ALERT SERVICE BULLETIN

NO. 212-01-113

MODEL AFFECTED: 212

SUBJECT: CHIP DETECTOR ASSEMBLY, TEDECO B3703

FIGURE 1

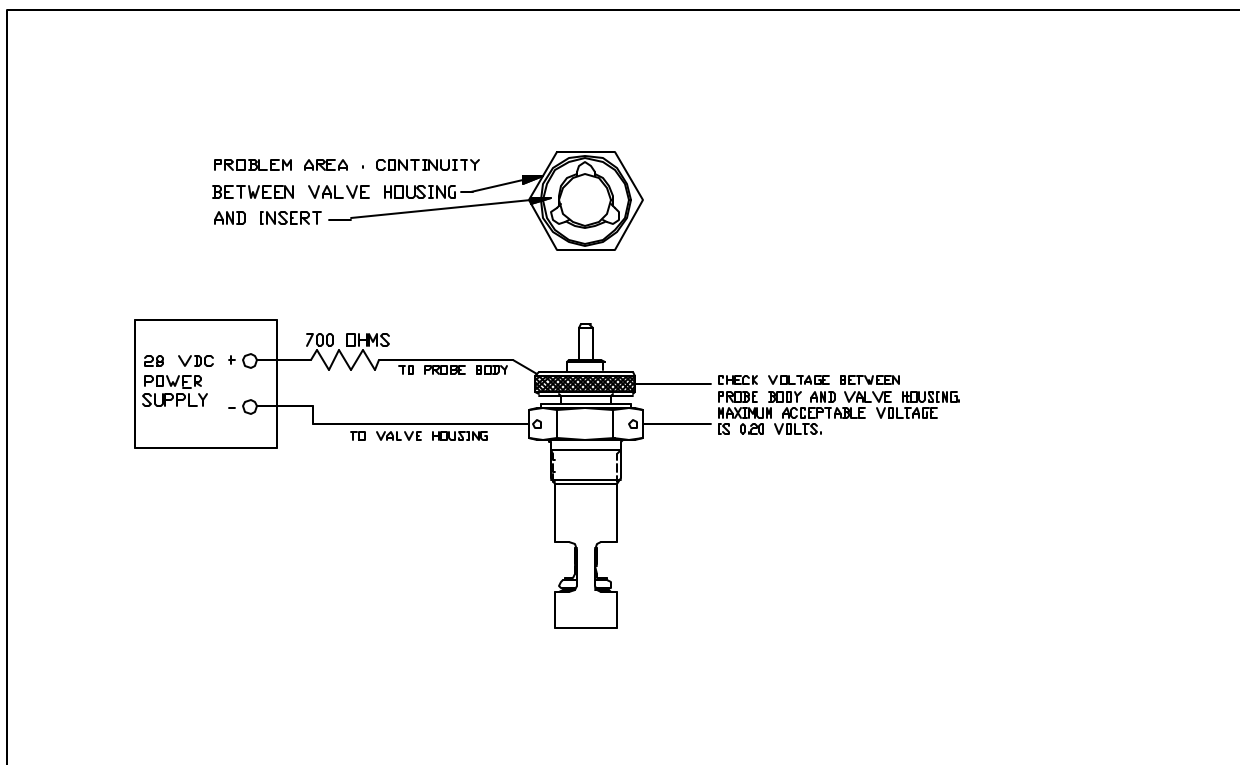
1. Connect the chip detector to a 28 Volt DC power supply using a 700 ohm, 2 watt resistor as shown in Figure 1.
2. Measure the voltage between the probe body and the valve body. The voltage drop must be 0.20 volts or less across the unit. If the voltage drop is larger than 0.20 volts, then return the unit to Tedeco (See 3. Part Replacement.)

FIGURE 2

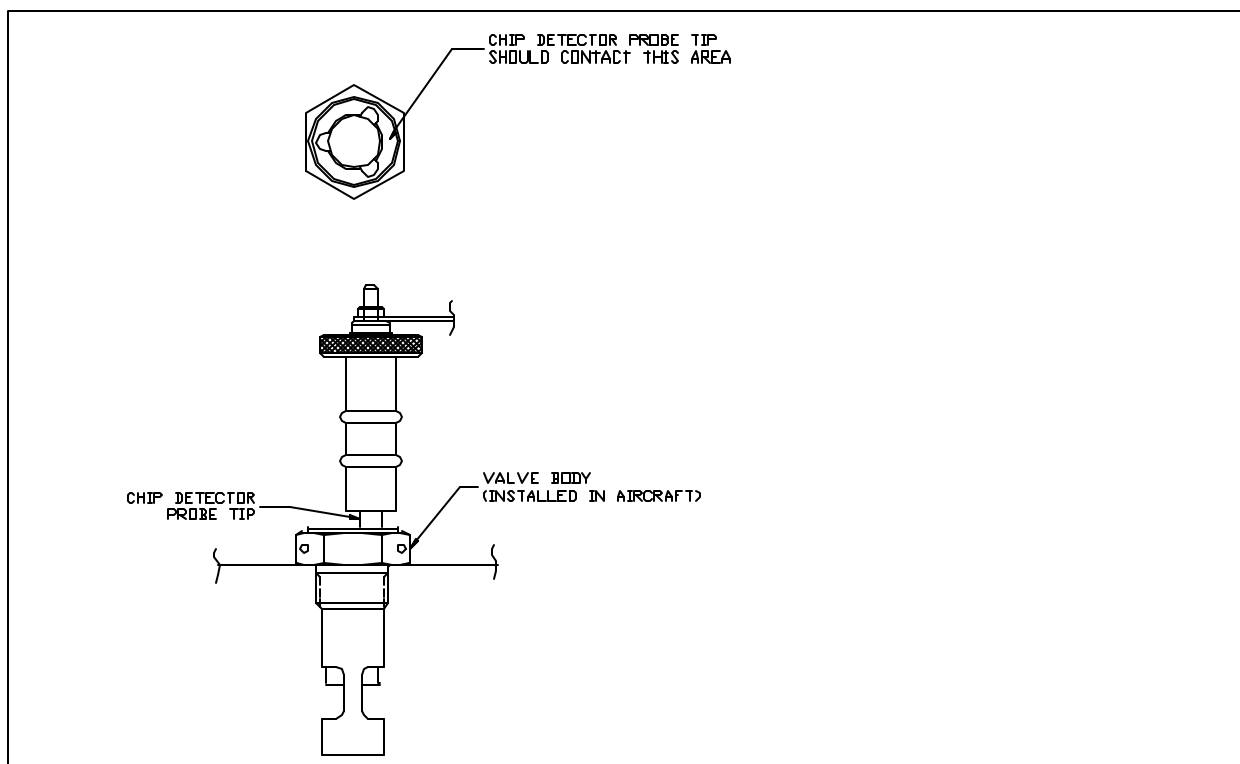
1. Ensure that electrical power is supplied to the chip detector.
2. Remove the chip detector probe from the self-closing valve.
3. Hold the tip of the center stud of the chip detector probe firmly against the steel insert as shown in Figure 2 while checking chip indicator light in cockpit. If the cockpit light illuminates, the unit is acceptable. If the light does not illuminate, then proceed to the next step.

FIGURE 3

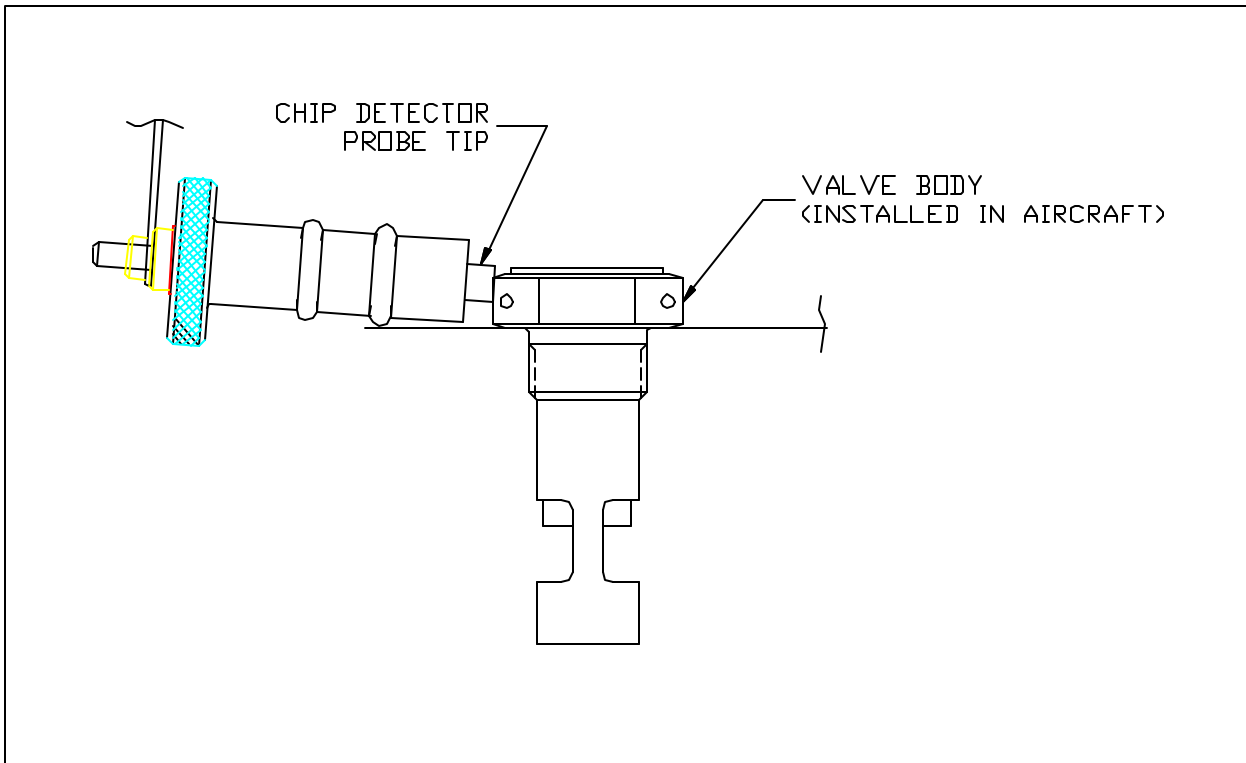
4. Hold the tip of the center stud of the chip detector probe firmly against the valve housing as shown in Figure 3 while checking chip indicator light in cockpit. The cockpit light should illuminate. Illumination of the light in this step isolates the electrical discontinuity to the valve insert. Repair the unit per the repair instructions in section 2 of this document.

FIGURE 4A

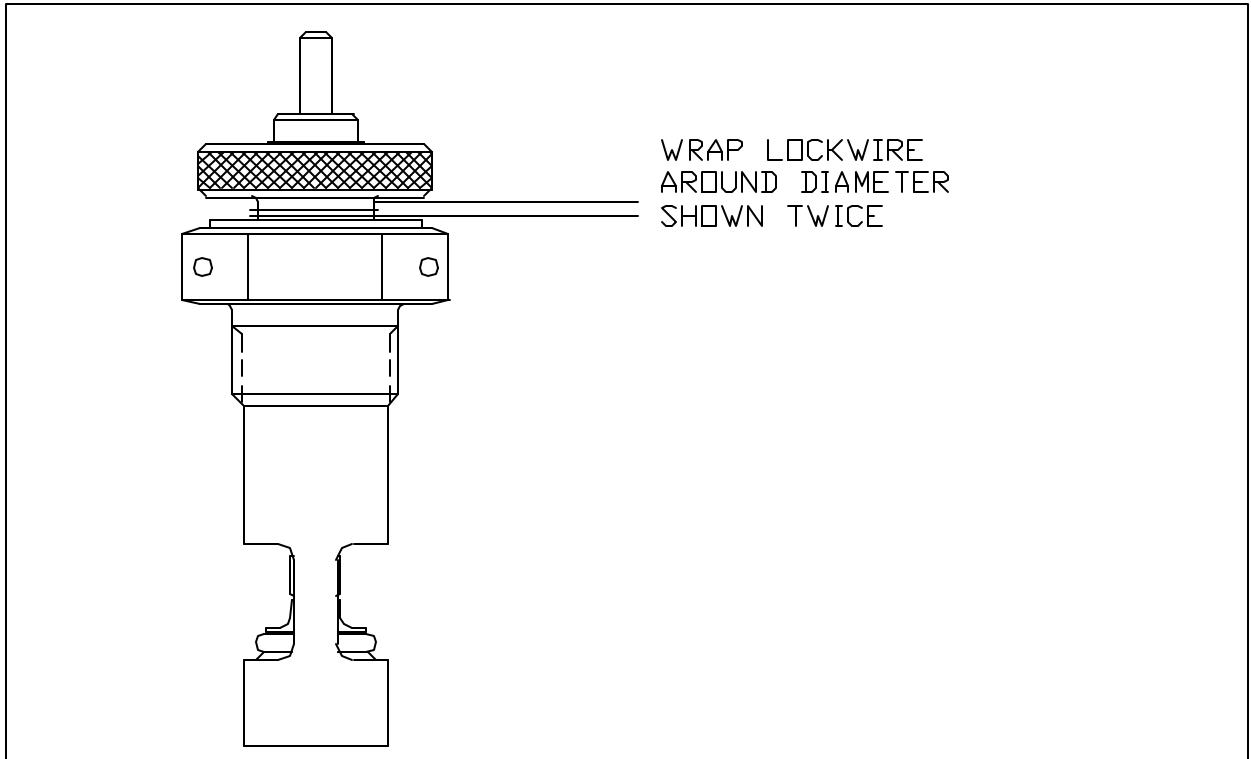
- 2.1. Install Chip Detector Probe into Valve assembly.
- 2.2. Tightly wrap a piece of lockwire (approx 6 inch length) around the chip detector probe diameter shown two full times. (See Figure 4A.)

FIGURE 4B

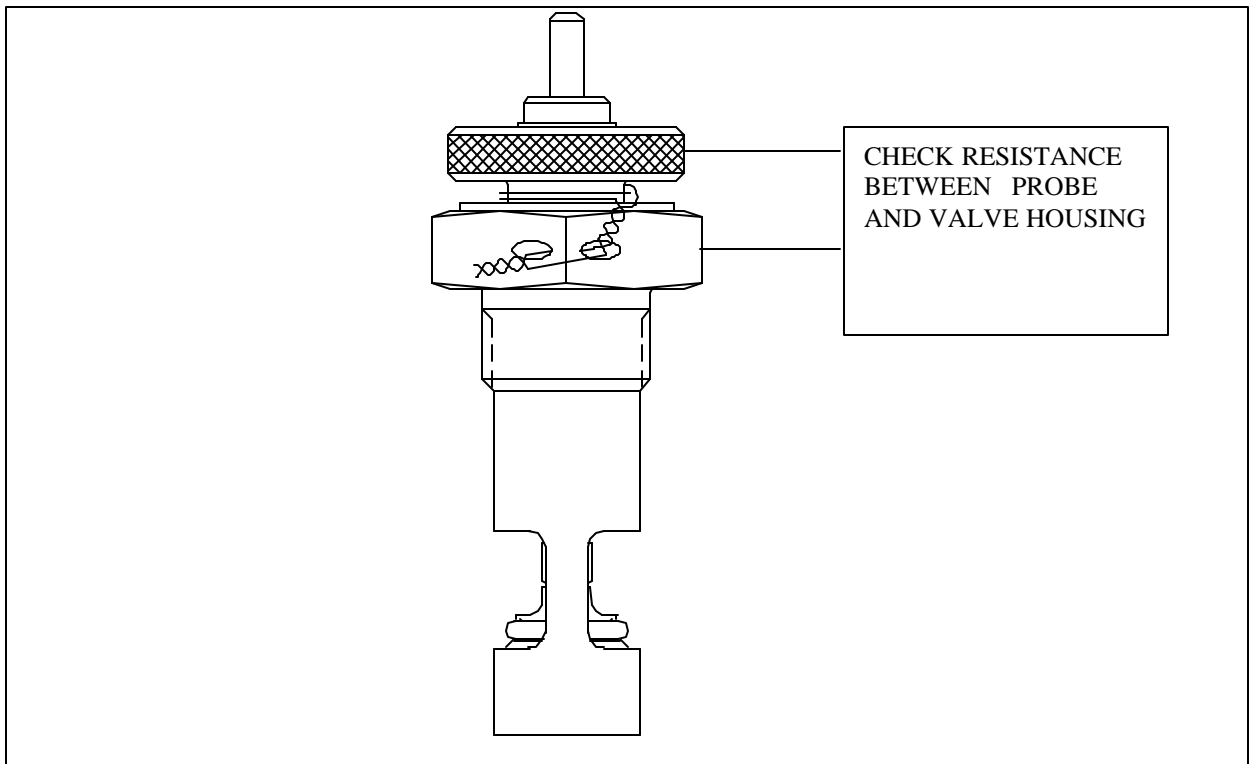
- 2.3. Twist two ends together approximately five times until twisted section reaches nearest free lockwire hole. Ensure that lockwire is tightly wrapped.
- 2.4. Slide one end of lockwire through the lockwire hole. Continue twisting two ends together to complete the lockwiring. (See Figure 4B.)
- 2.5. Check repair by using an ohmmeter to check resistance between the chip detector probe and the valve housing. Resistance should be 1 ohm maximum. (See Figure 4B.)
